# ***Altronic Service Bulletin #527 A***

ISSUED: 06/10/22

## **Altronic V-NG Upgrade Improvements**

Location of the H-E components:

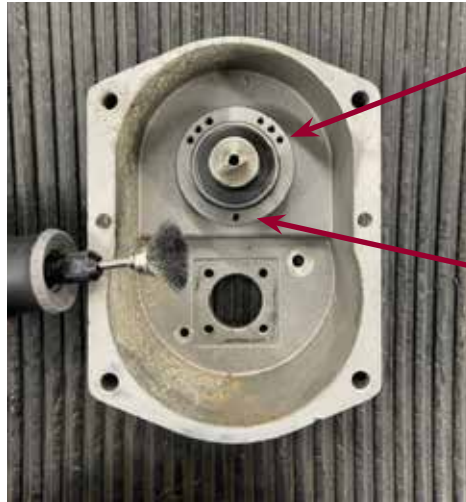
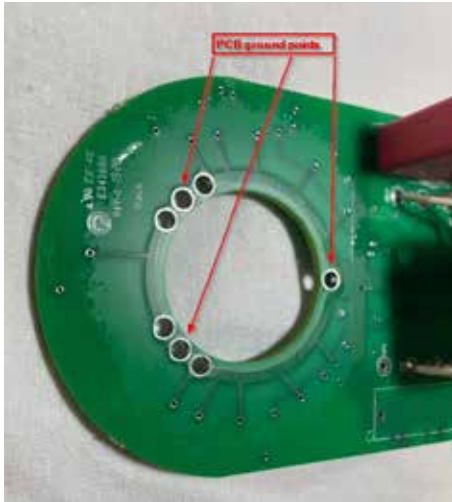
The easiest gap to measure is that between the components located at the 4 and 8 o'clock positions. The GO feeler gauge is yellow and is .020" and should slide between the magnet holder and the H-E component. The NO-GO gauge is orange and is .030" and should not fit between the magnet holder and the H-E component.

Add shims beneath the Magnet Holder Gear as necessary to attain the proper gap. The shims are part number 902579 and are the same part used in the Legacy Altronic V for this same purpose.

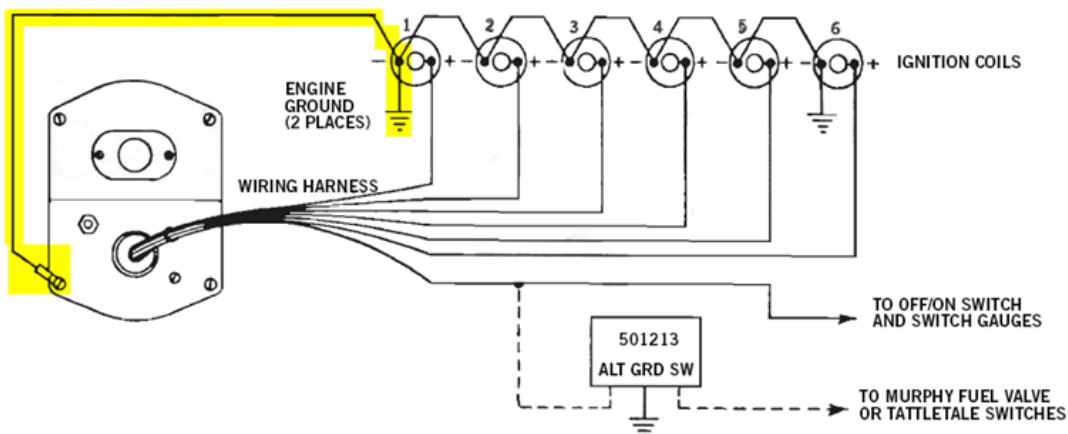
PCB mounting hardware has been improved to allow for variances in the tapped hole depth in legacy back covers. The revised screw is shorter (5/16" vs. 3/8") and includes a nylon thread locking patch for vibration resistance. The conical washers have serrations that lock the assembly even further. Items 18 and 20 in the Service Manual detail the part numbers for these items, and are sold in bulk packs of 25 pieces should additional items be required beyond these items in the hardware pack.
